High K signal

P802.3db Draft 3.0 comment 36

Piers Dawe, Nvidia

May 2022

Troublesome signal at TP2

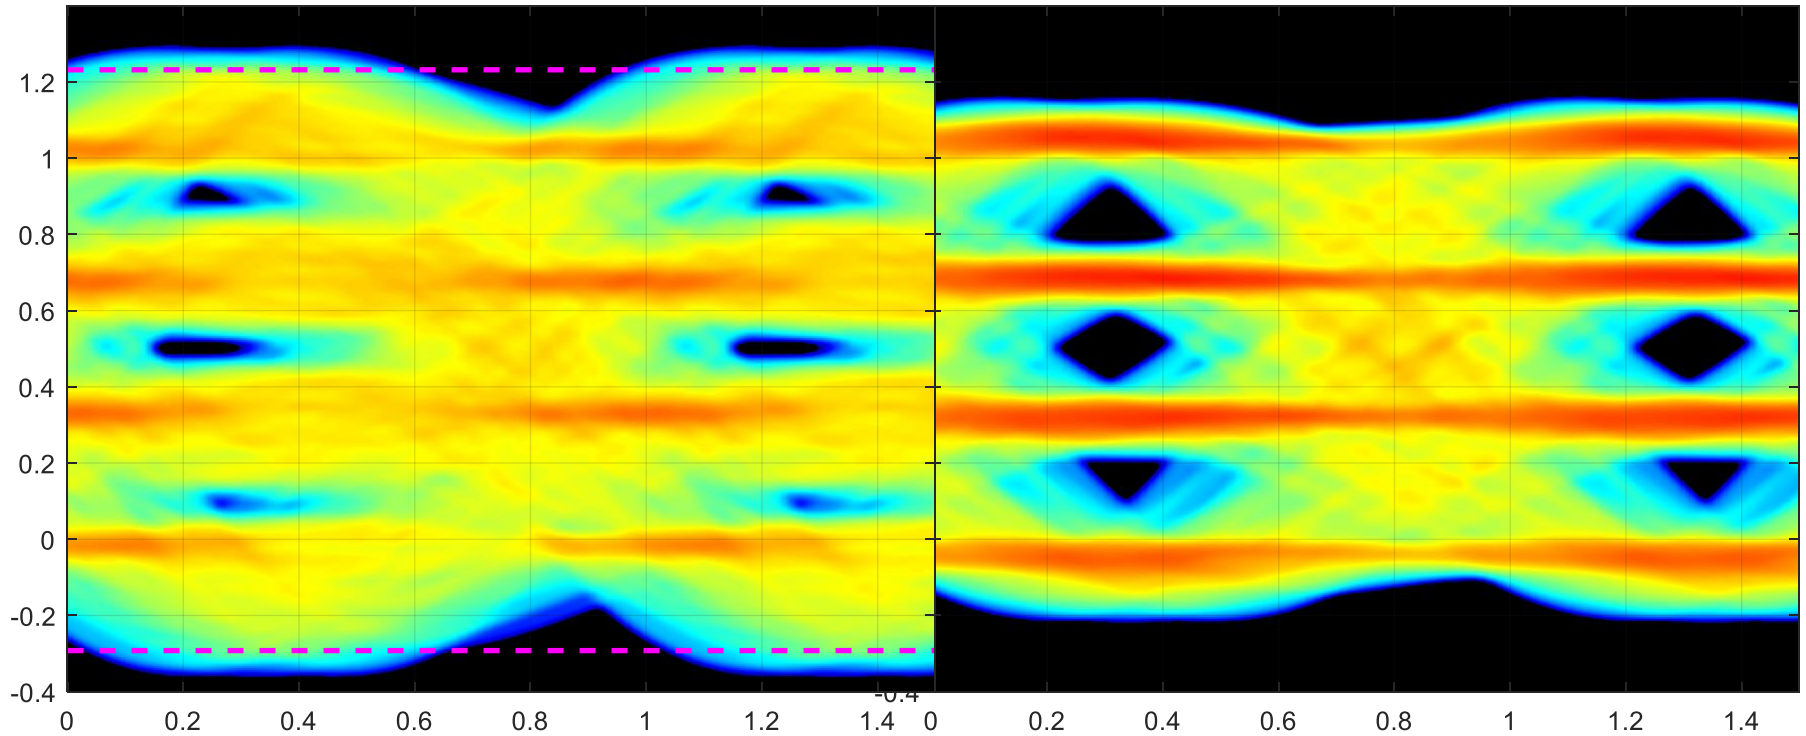
- This bad signal has high K' and high but legal overshoot, a bad combination for receivers.
- Yet the point of a separate VR spec was to allow slower transmitters than are needed for SR, so VR transmitters should not be in this corner.

- This is worse at TP2 than after a minimum-bandwidth optical channel at TP3.
- The K' limit is similar to VEC in C2M and EVM in coherent: a screen for signals that are bad after equalisation. As it is a free by-product of the TECQ measurement, we can add it to exclude these untypical signals that don't benefit transmitter makers but are bad for receivers.

- *Suggested Remedy*
- For VR, insert a row for $K' = \text{TECQ} - 10 \cdot \log_{10}(\text{Ceq}')$, limit 4.4 dB, same as the TECQ limit. K' and Ceq' are the two parts of TECQ as K and Ceq are the two parts of TDECQ.

Same troublesome signal at TP3

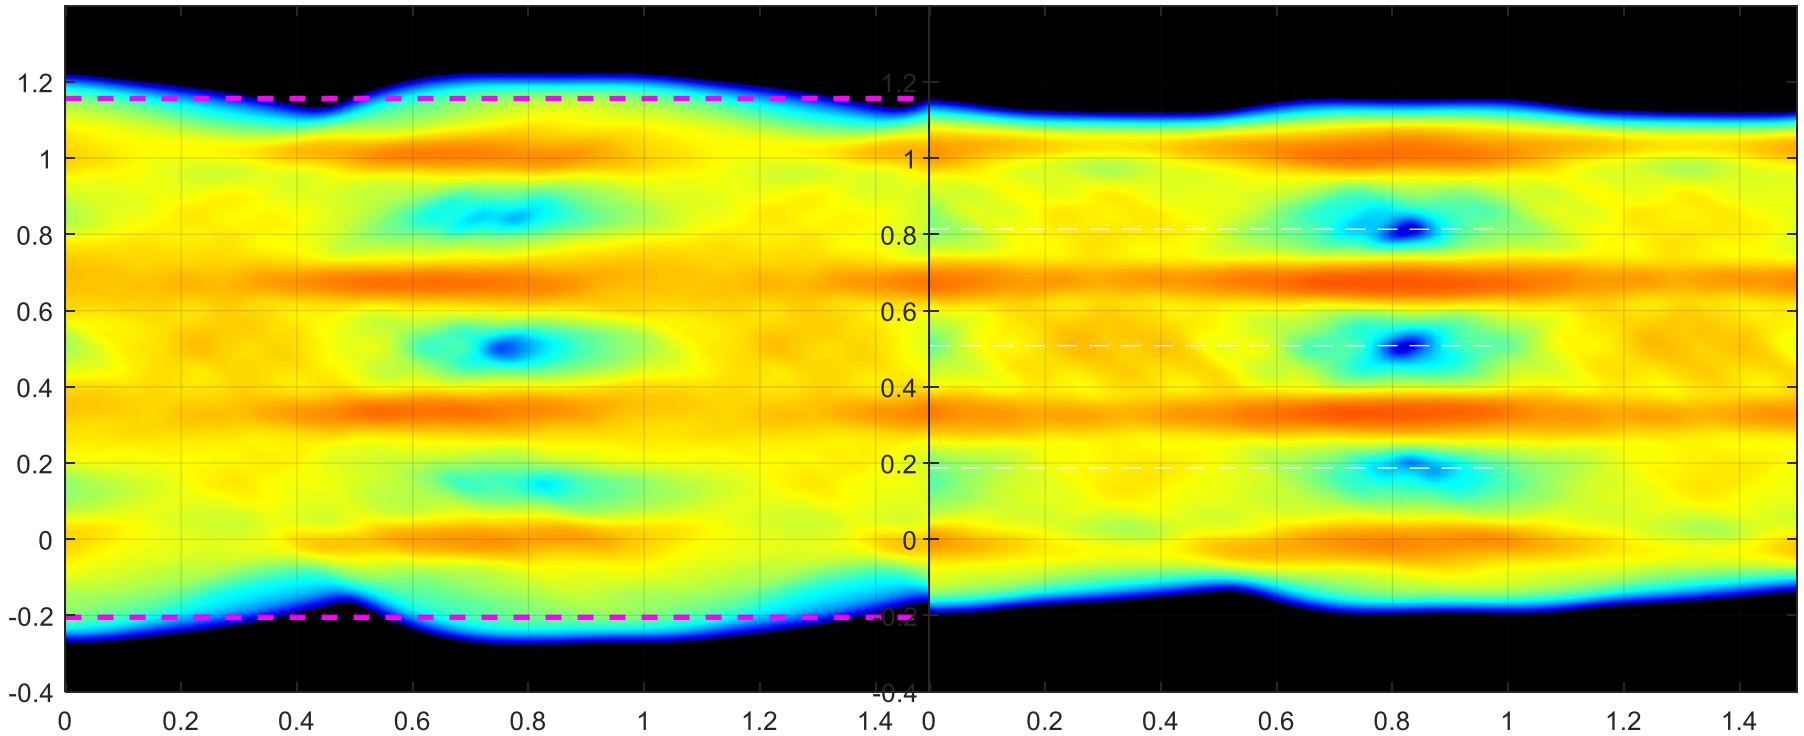
- TDECQ solver missed the solution?
